**Subject: SoGreen and Parramore Fertilizer Sites
Semi-Annual Progress Report No. 1 required under Consent Order No. EPD-VRP-015**

**Subject: Response to October 31, 2017 EPD Comments
Parramore Fertilizer Site (PFS)**

In conjunction with the submittal of the Voluntary Remediation Program (VRP) February 2019 Progress Report #1 for the above-referenced site (PFS), this letter provides a response to EPD's October 31, 2017 comments on the Site Voluntary Investigation Remediation Plan (VIRP) dated May 5, 2017.

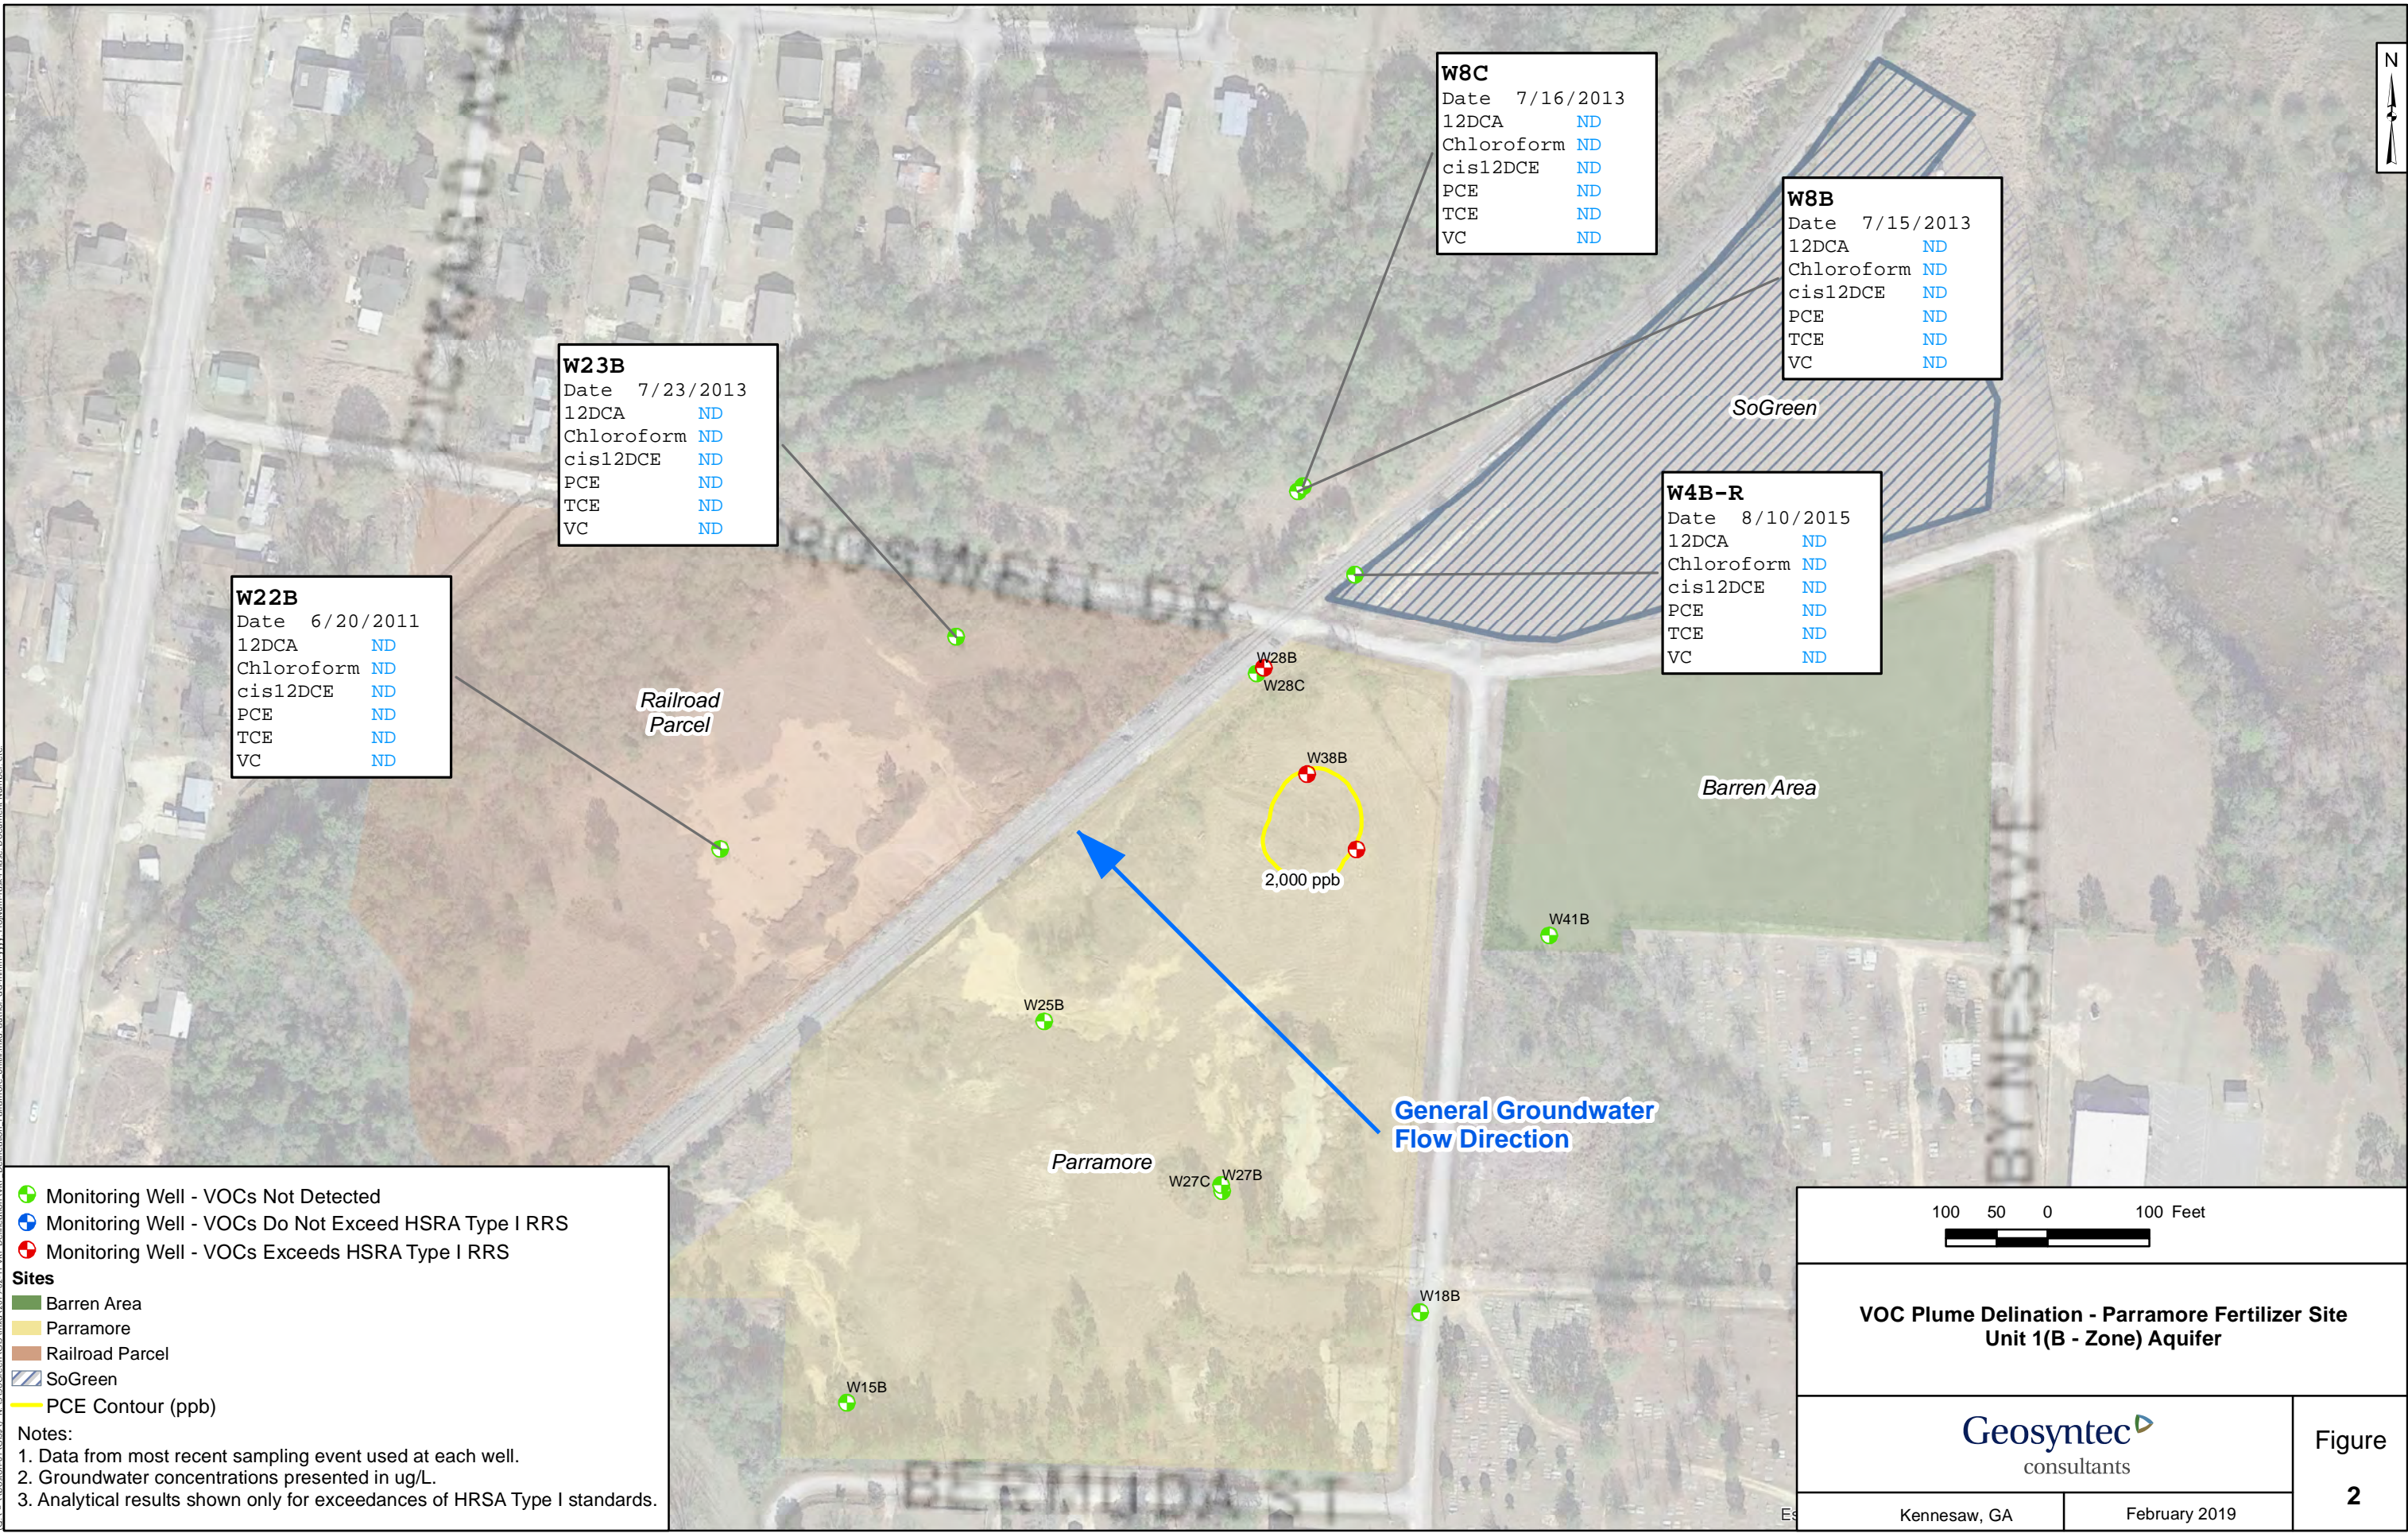
Please ensure that supporting documentation is provided in the first progress report to demonstrate that horizontal groundwater delineation is complete.

As stipulated in the Consent Order, the horizontal extent of the release to groundwater emanating from the PFS has been delineated consistent with the requirements of the VRP Act. The data utilized in making this conclusion is attached in the form of a groundwater quality data map which demonstrates that the horizontal delineation is complete.

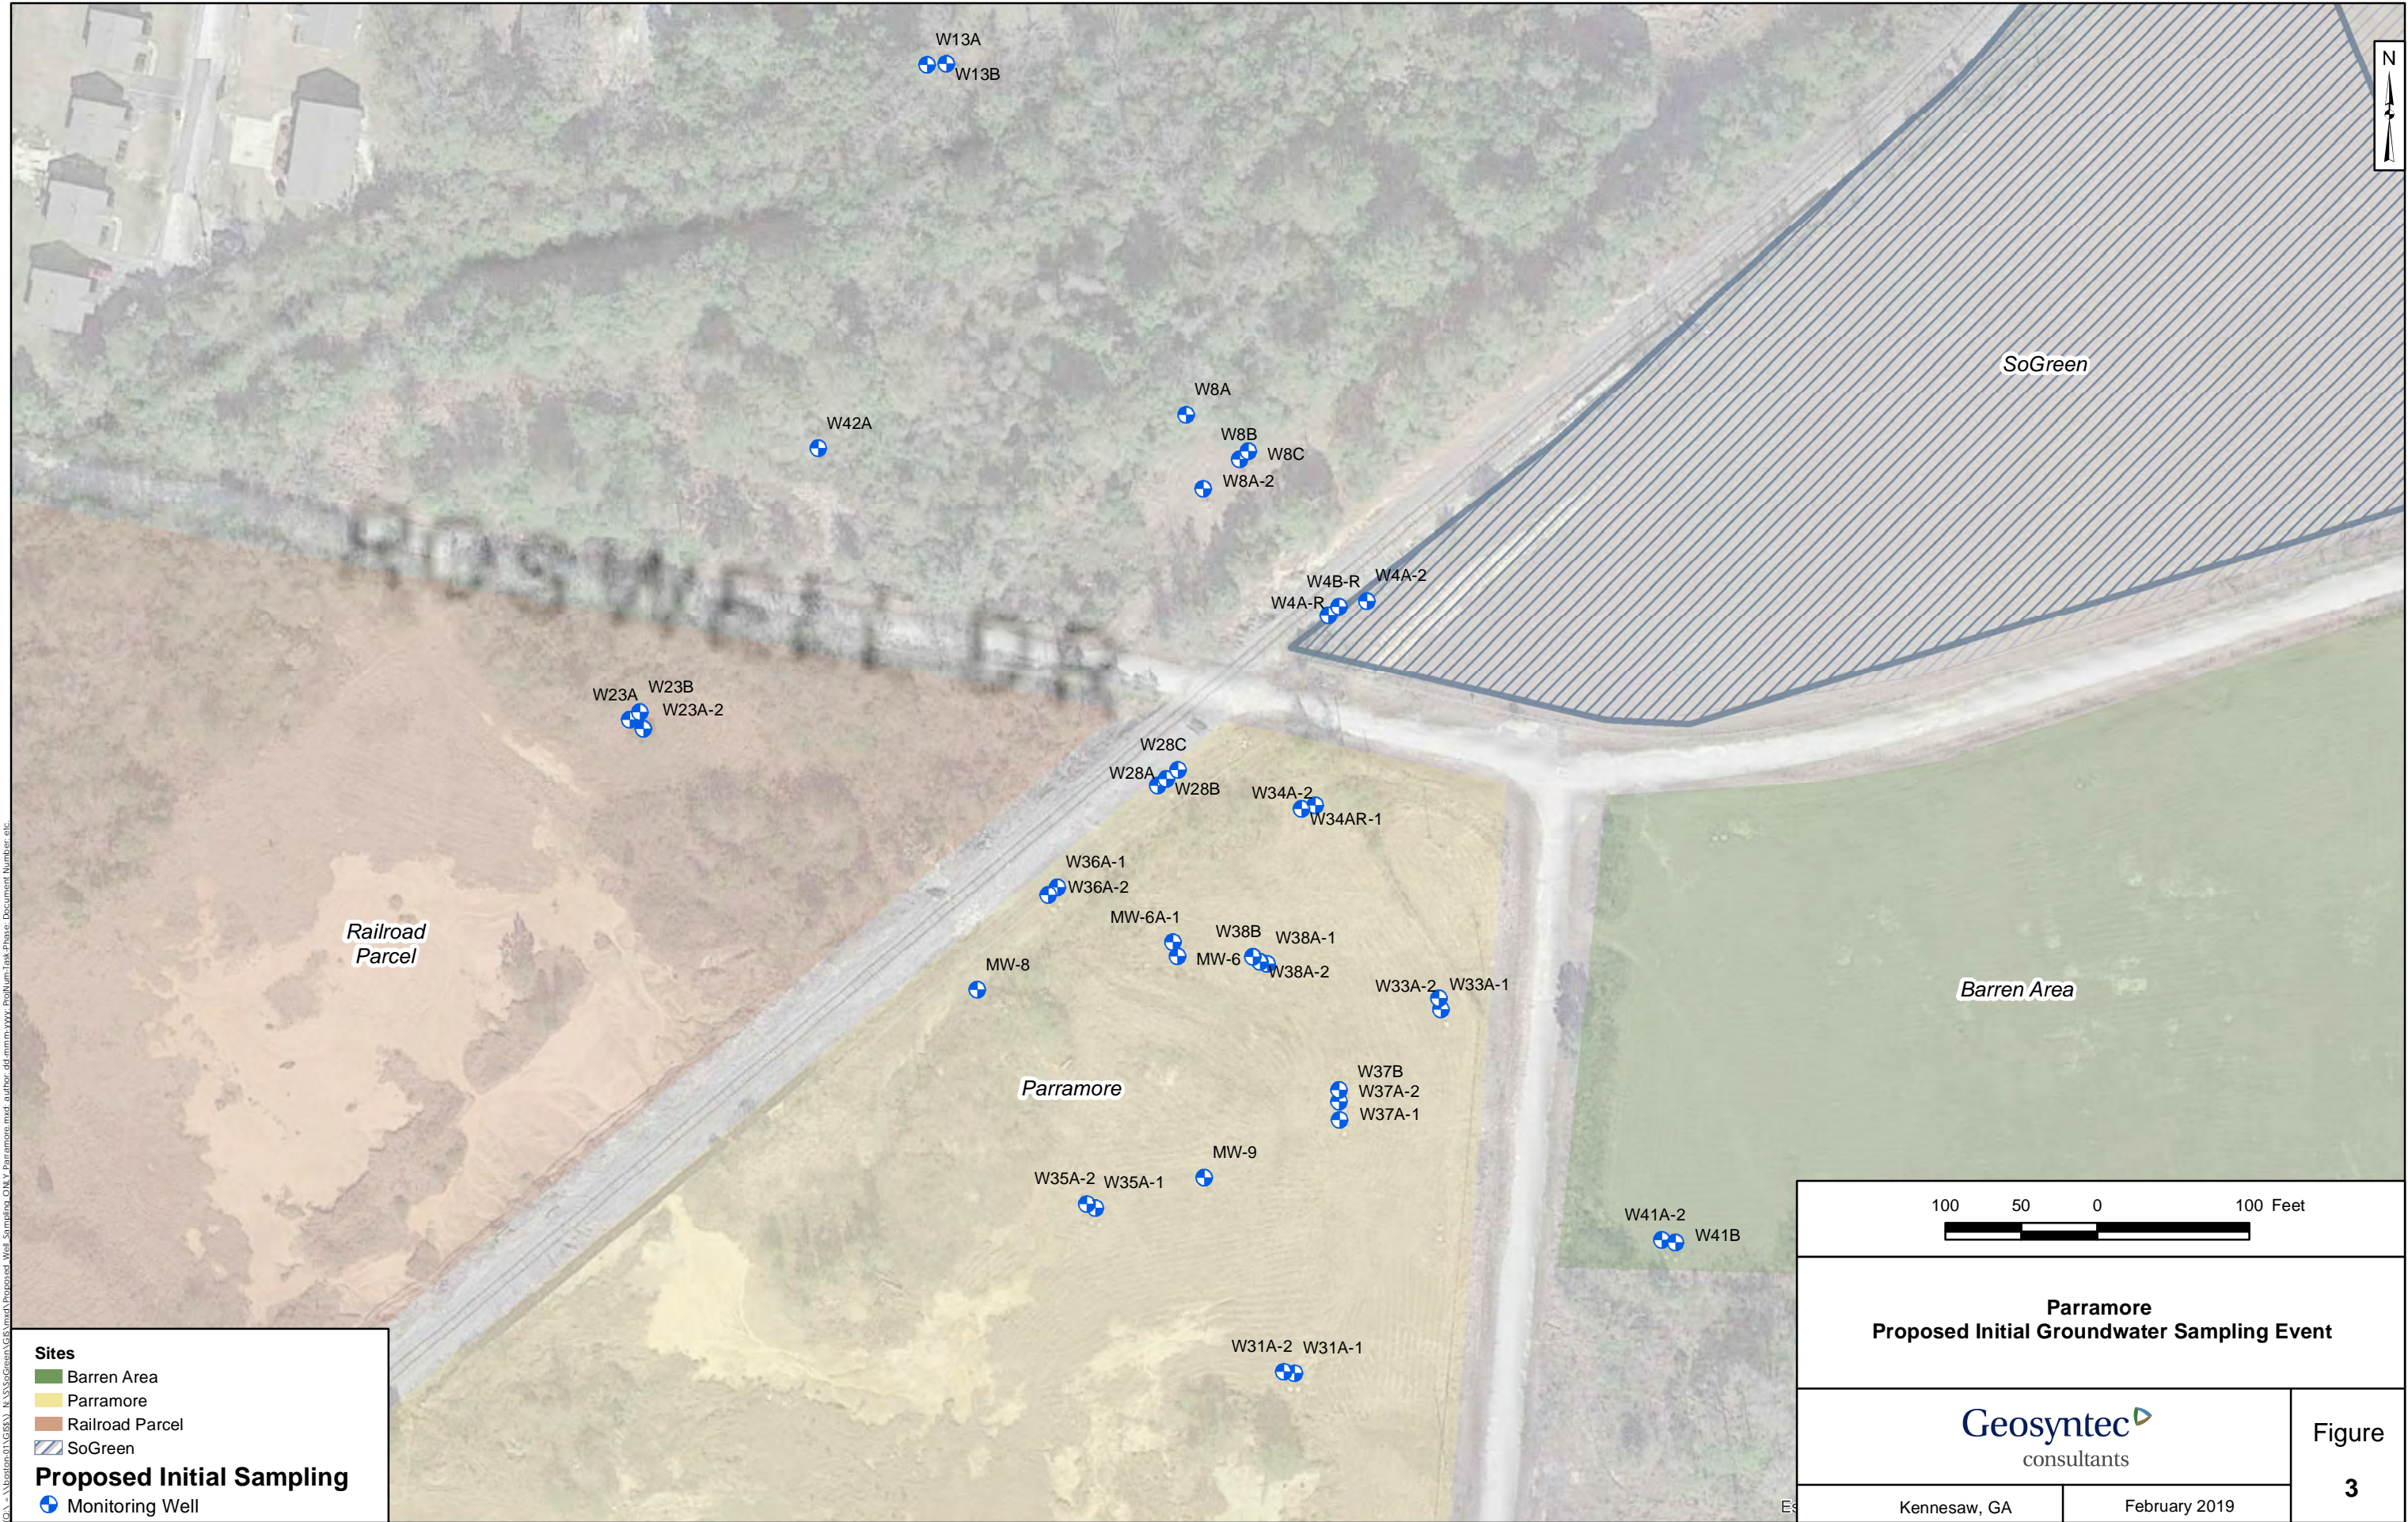
Please update the groundwater sampling approach in Section 5.3.1 of the VIRP to include a list of the specific monitoring wells proposed to be sampled and rationale for the selection of wells to be incorporated into the site related monitoring plan. EPD requests that this information be provided 45 days prior to the first sampling event.

The specific wells to be sampled and associated rationale for the baseline VRP sampling event are provided on the attached table and figure. The wells and analyte list for future groundwater sampling events may be modified based on the initial sampling results and the selected remedy and will be communicated to EPD prior to additional sampling.
